NOTICE OF INTENTION TO DRILL OR RECOMPLETE

The Atlantic Refining Company

State "T"

We are returning unapproved Form C-101, Notice of Intention to Drill State T #6, 2310 ft. from the North line and 2310 ft. from the West line Sec. 2 T 15S R37E Lea County, New Mexico. According to my calculations this location is unorthodox by a matter of 13.49 feet.

Operator THE ATLANTIC REFINING COMPANY
 Lease STATE "T" (B-9774)
 Field DENTON POOL
 Description SW/4 SW/4, Sec. 2, T-15-S, R-37-E, Lea Co., N.M.
 Date Plat Drawn Jan, 5, 1951

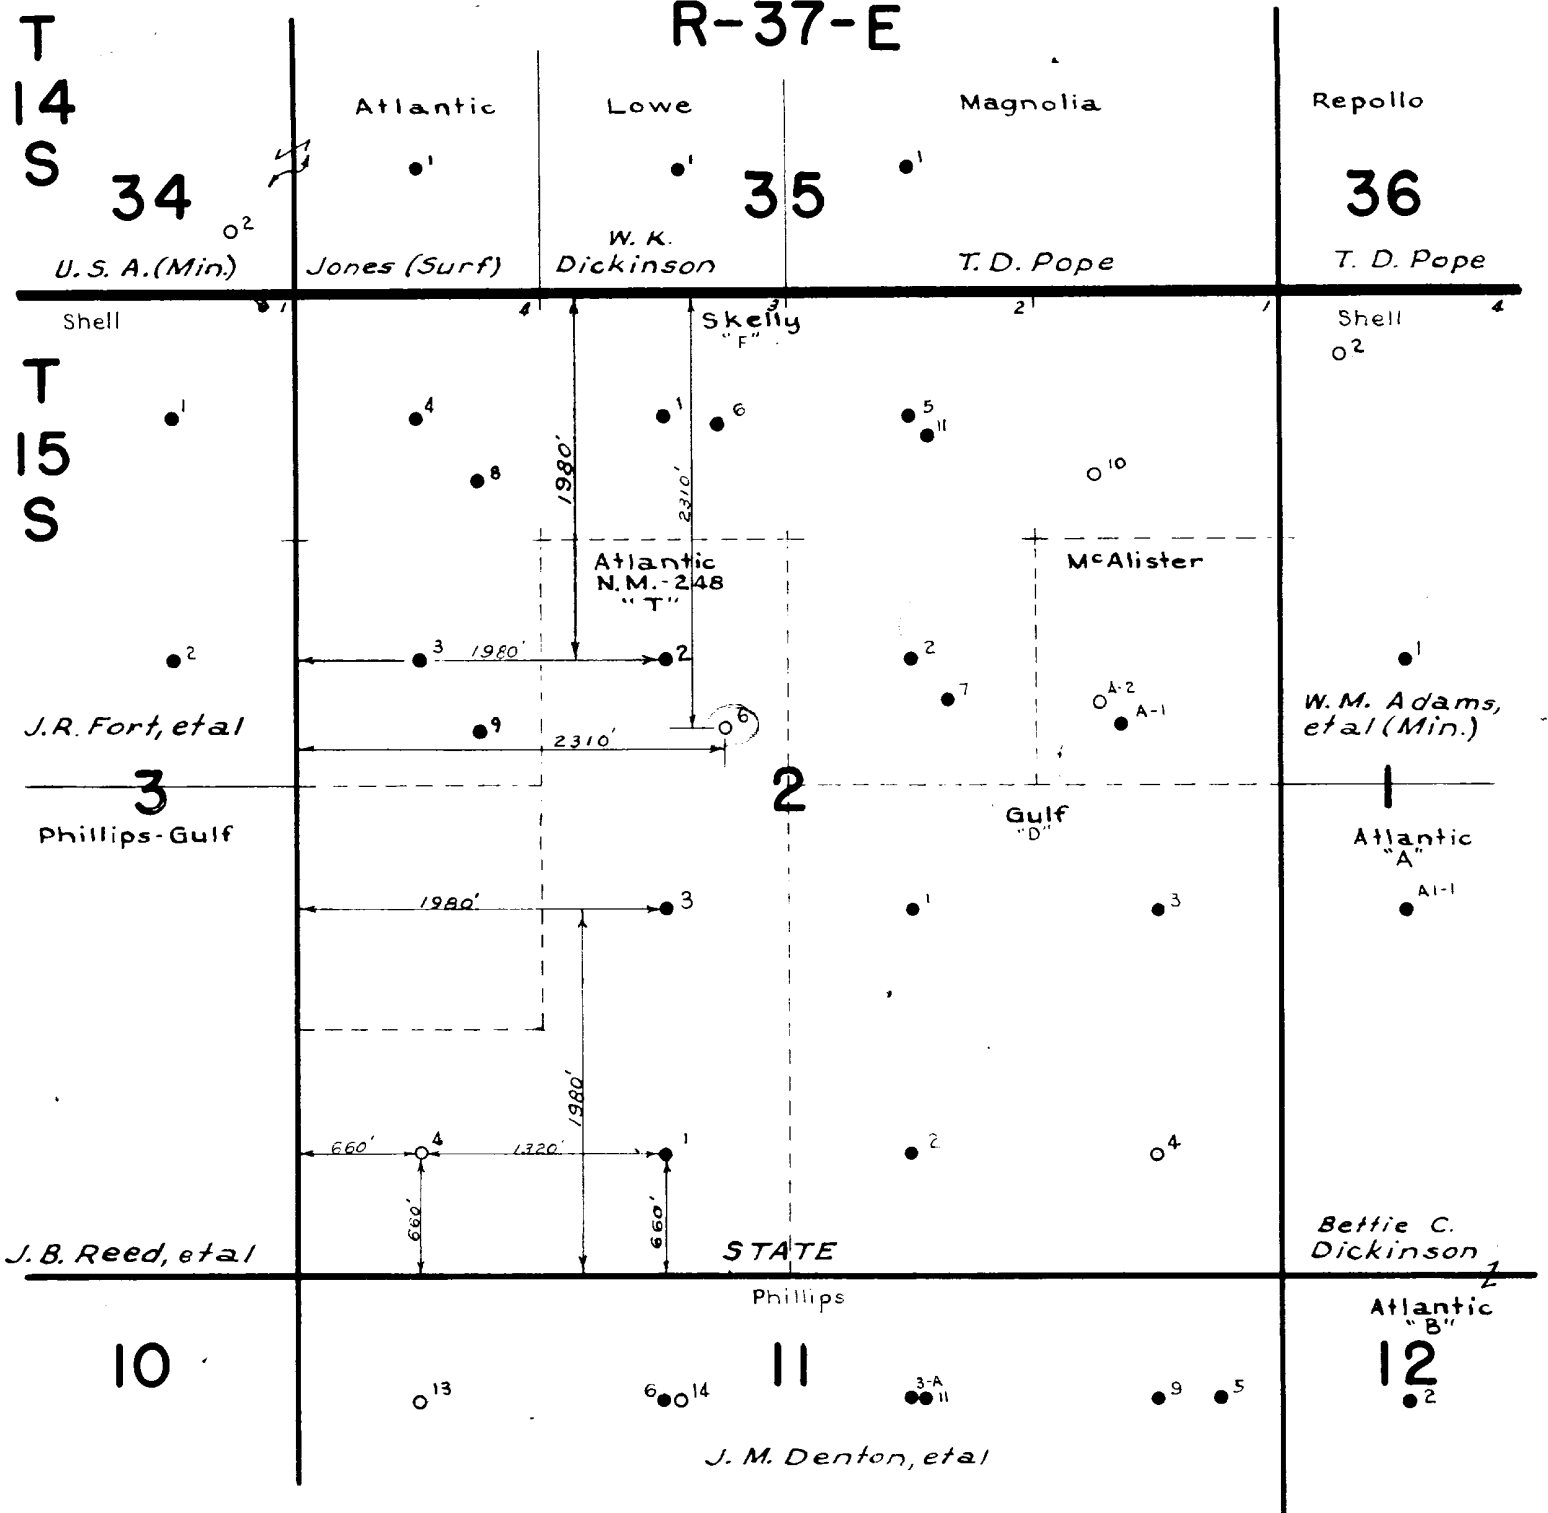
Section 2 is against a correction line and land office survey plat sheets indicate the west side of Section 2 to have a length of 79.66 chains or 5257.56 feet. The east line has 79.97 chains or 5278.02 feet. I am calculating the North South length of Section 2 at a point 2310 from the west line. A fraction of $2310/5280$ times the difference in length between the east and west lines gives 8.95' which added to the length of the west line gives a computed length of Section 2 at a point 2310 from the west line of 5266.51. This correction is made in the lots along the north side, leaving the distance from the north section line to the south line of SE NW 1/4 1/4 section at 2626.51 feet at a point 2310' east of the west line, 2626.51 feet minus 2310 leaves 316.51 as the distance of location from the south line of 40 acre unit.

Section C of Rule 104 precludes the approval of locations closer than 330' to the edge of the 40 acre units on which they are to be drilled. If you will move this location 14 feet north and show it as 2296 feet from the north line, it will comply with Rule 104 and will be approved.

Subject to commission approval
of unorthodox location
